Reponse Reviewer 1

Reponse Reviewer 2

From lidar scans to roughness maps for wind resource modeling in forested areas

Figure 1. Terrain (left) and tree height (right) maps of the site derived from Airborne Laser Scans with a 20m resolution. The dashed rectangle indicates the area covered in Fig 2, and the numbered points show the locations of the seven masts.

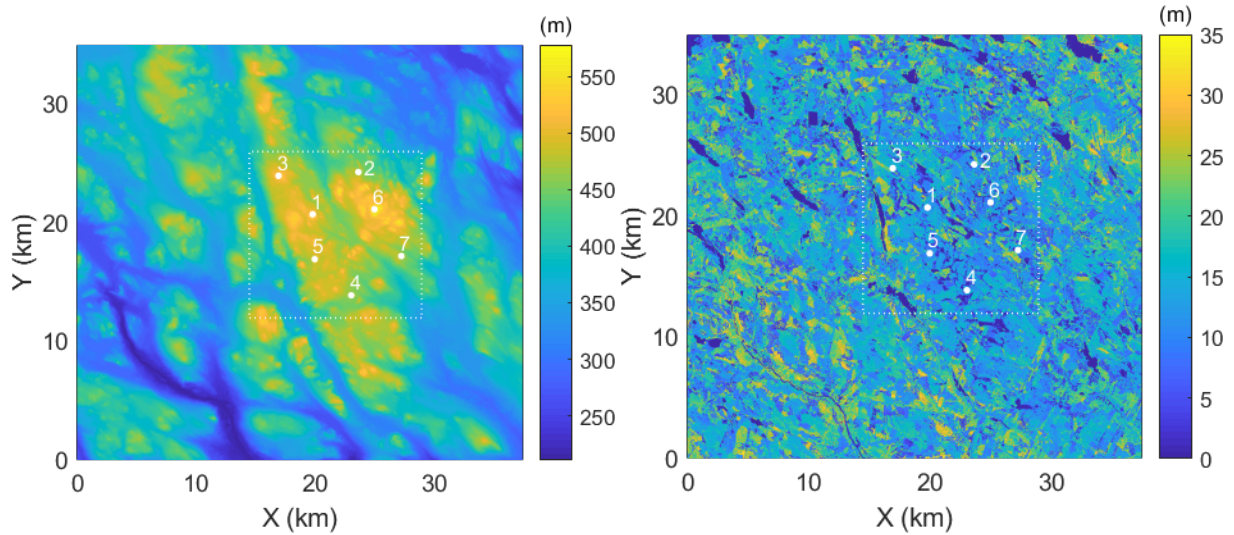
- p8l16: Figure 1 shows the tree heights (right panel) and elevation (left panel) derived...

- p8-Figure 1: Please use same ticks in axes X and Y. Also please specify that the units for elevation and tree heights are in m.

The references to the panels were added.

The figure now has the same ticks on both axes and the units are given above the color bar.

Figure 2. Roughness maps from land-use datasets, and from ORA at 100 and 500 m resolutions, colored by roughness valuevalues. Open circles show mast locations.

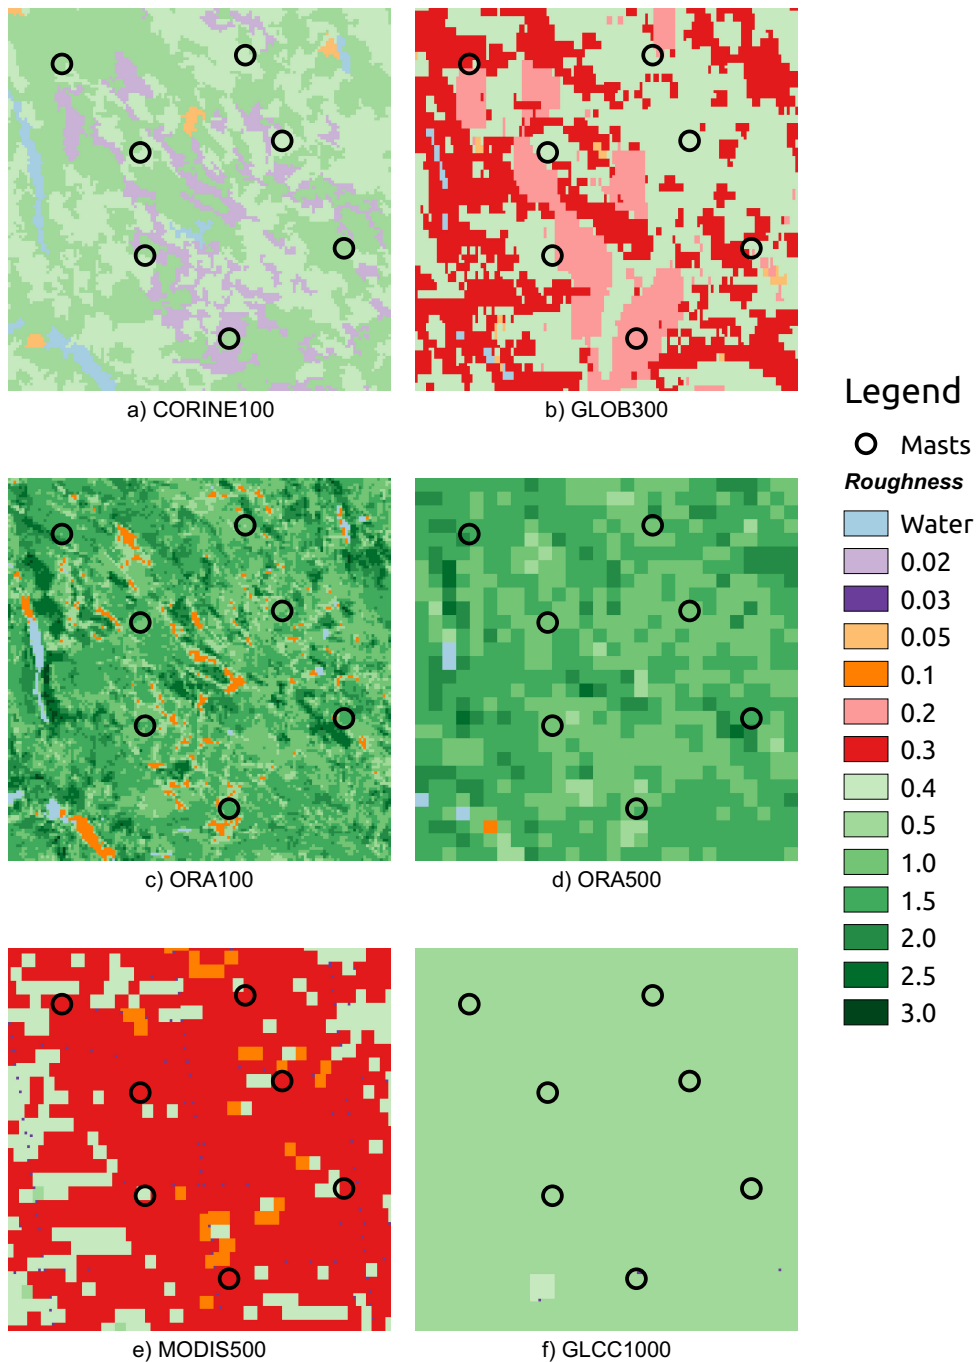
- p14-Figure2. Suggested new title: Roughness maps from land-use datasets, and from ORA at 100m and 500m resolutions, colored by roughness values. Open circles...

We changed this to: "Roughness maps from land-use datasets, and from ORA at 100 and 500 m resolutions, colored by ..."

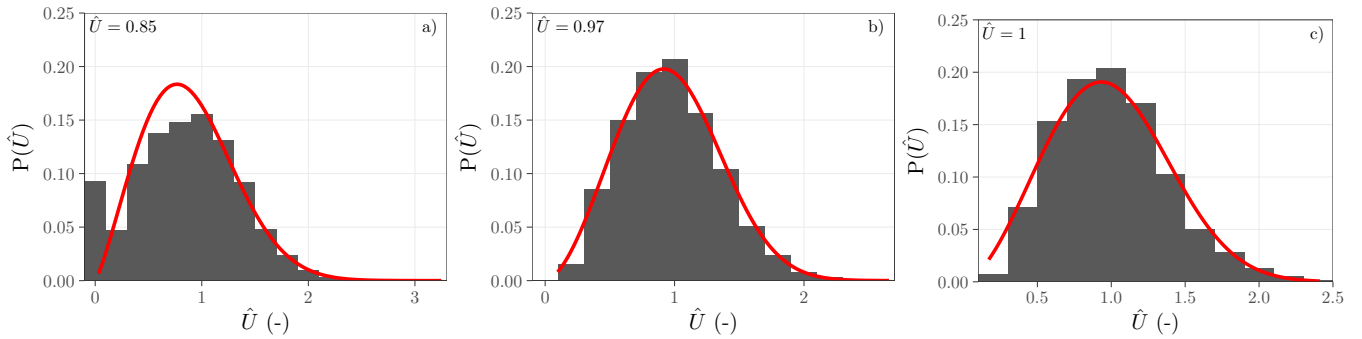
- p15. Figure 4: please remove 'the' before WAsP.

Corrected.

Figure 6. a) The mean Mean absolute error in wind speed (%) or and b) power density for all simulations using a landuse land-use description with a resolution of 100 m

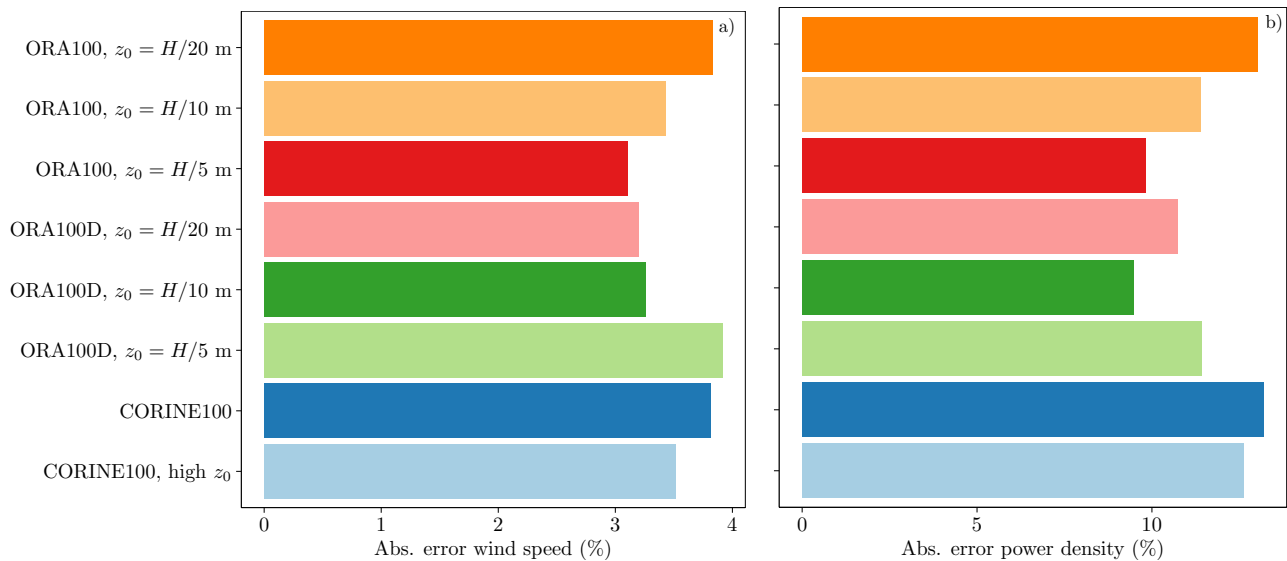
- p17-Figure6. Suggested new title:

a) Mean absolute error in wind speed (%) and b) power density...

Changed as suggested.

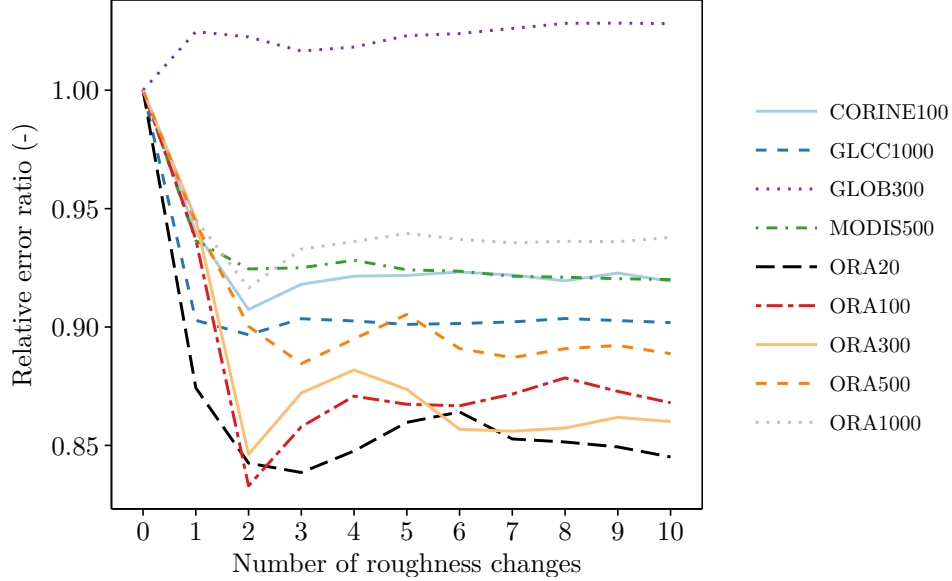
- p19-Figure 7. The title describes the graph as mean absolute error, while the Y axis on the graph reads 'Relative error'. Please correct accordingly.

We modified the caption (see new caption Fig. 7).

Figure 8. The ~~mean~~ Mean absolute error in wind speed as a function of the geostrophic roughness length when using the default WAsP settings but with the roughness change model switched off.

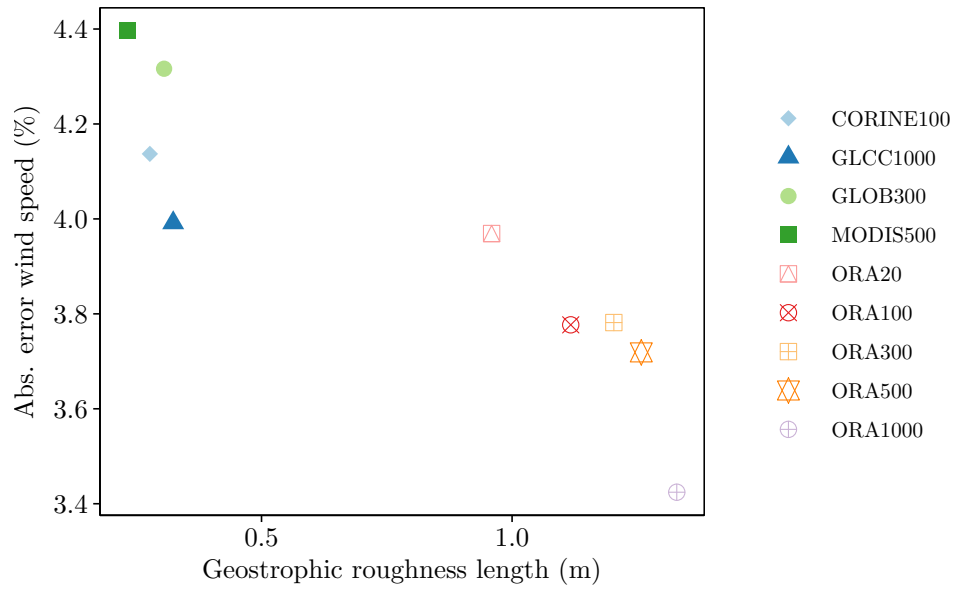
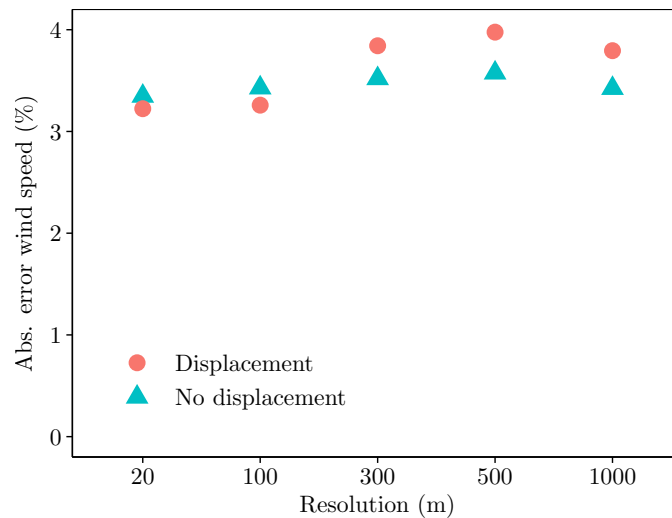
- p20-Figures 8 and 9: Please remove 'The' at the beginning of titles.

This has been changed throughout the manuscript.
